Bicester Office Park

June 2018 ES Addendum

2. This ES Addendum prepared by Trium Environmental Consulting LLP (hereafter referred to as the 'June 2018 ES Addendum') has been prepared to accompany Original ES as a result of some minor amendments to the parameters plan, further assessment and consultation comments from CDC since the Original ES. Its purpose is to assess whether or not these changes will result in any new or materially different likely significant environmental effects when compared to those considered within the ES (as amended).

Figure 3 Revised Combined Parameter Plan

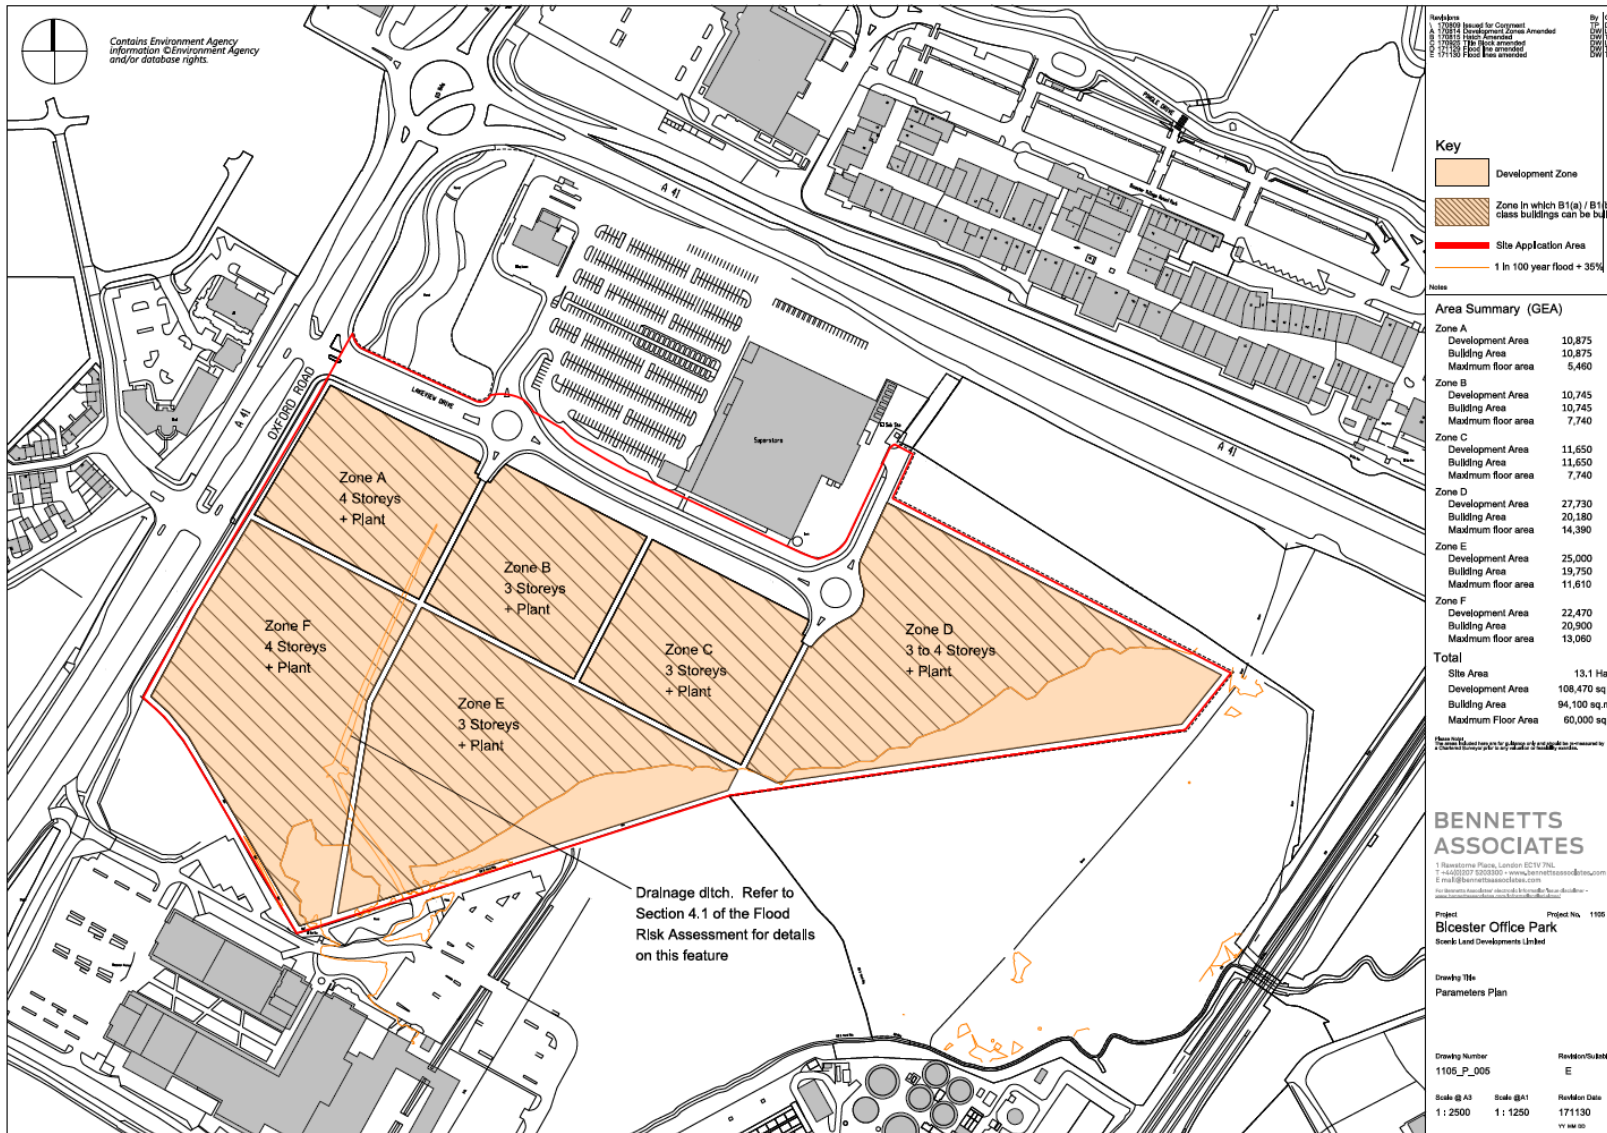
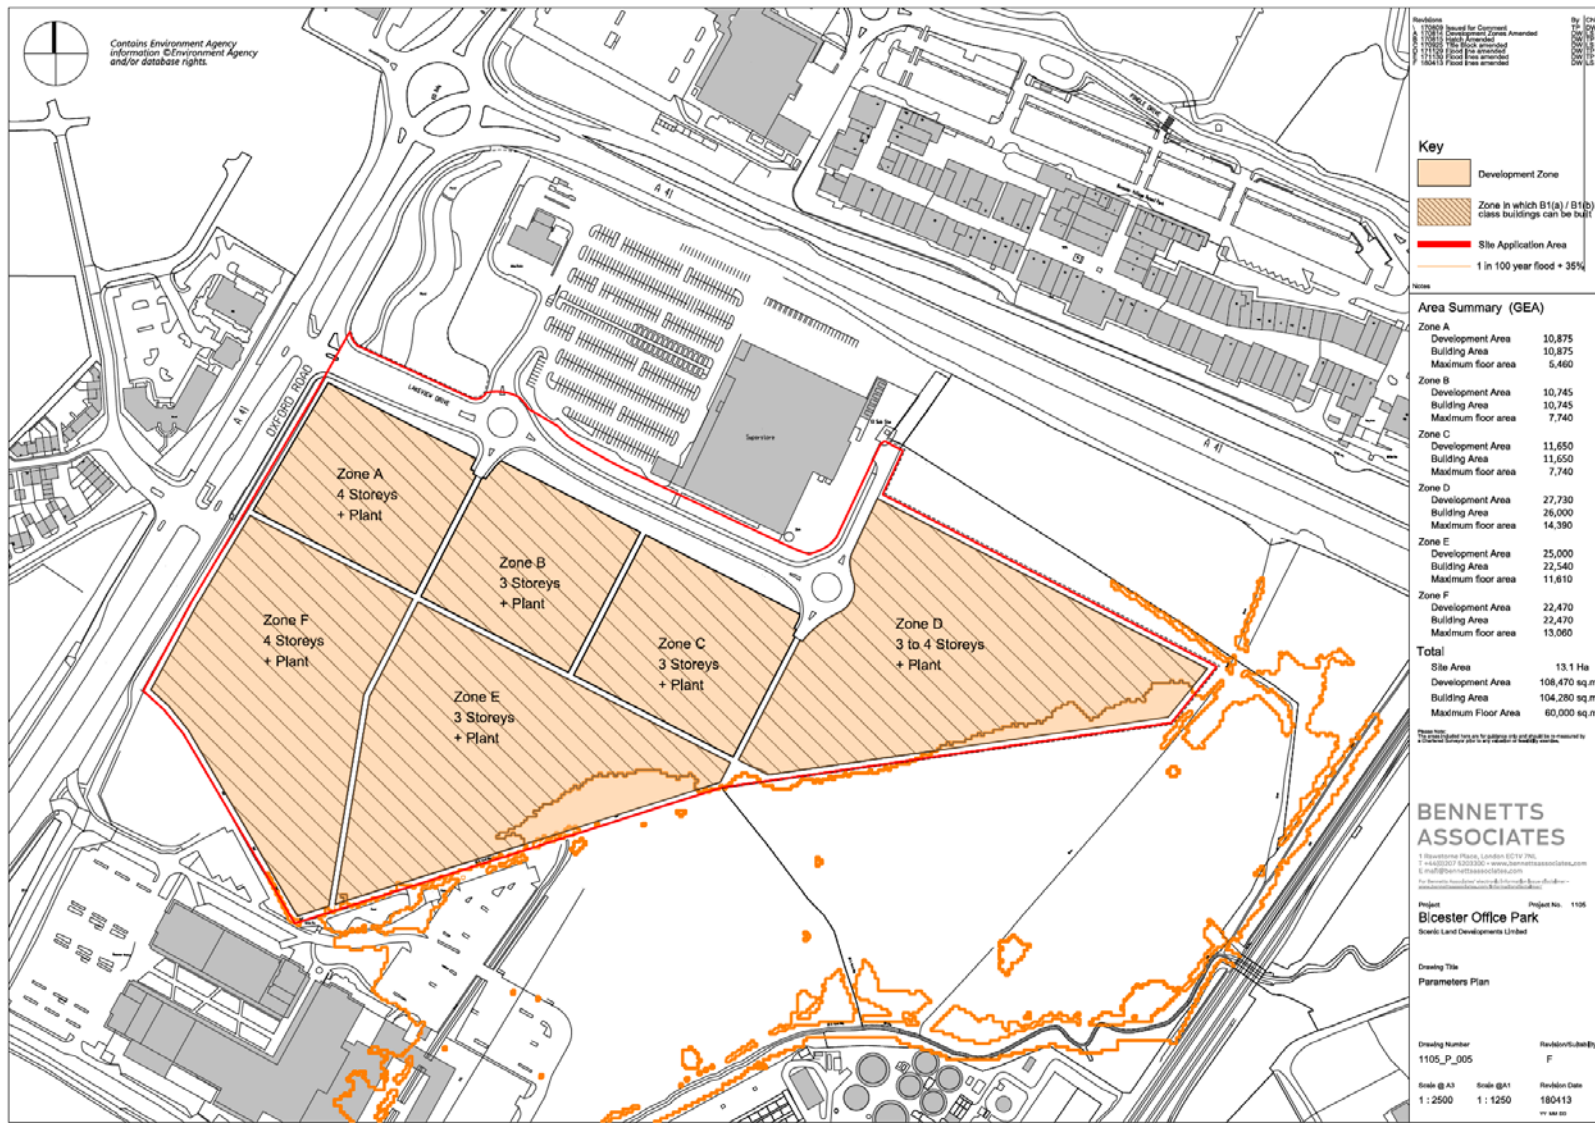
19. The combined parameter plan has been amended to take account of additional hydraulic modelling that has been undertaken to better inform the fluvial flood risk at the site. The revised flood extents and flood levels (1 in 100 Year flood (+35%)) have illustrated a lesser extent of the site that would be affected than previously envisaged. As a result, the Original Combined Parameter Plan zone in which B1(a)/B1(b) class buildings can be built has been extended (Figure 3 Revised Combined Parameter Plan). Whilst the footprint of the developable area has extended the maximum quantum of flood area is unchanged.

20. The proposed amendments to the combined parameter plan are considered marginal. The likely effects reported in the Original ES are unaffected by the extension to the developable area. This is because the maximum floor area is unchanged. The Revised Combined Parameter Plan is therefore not addressed any further.
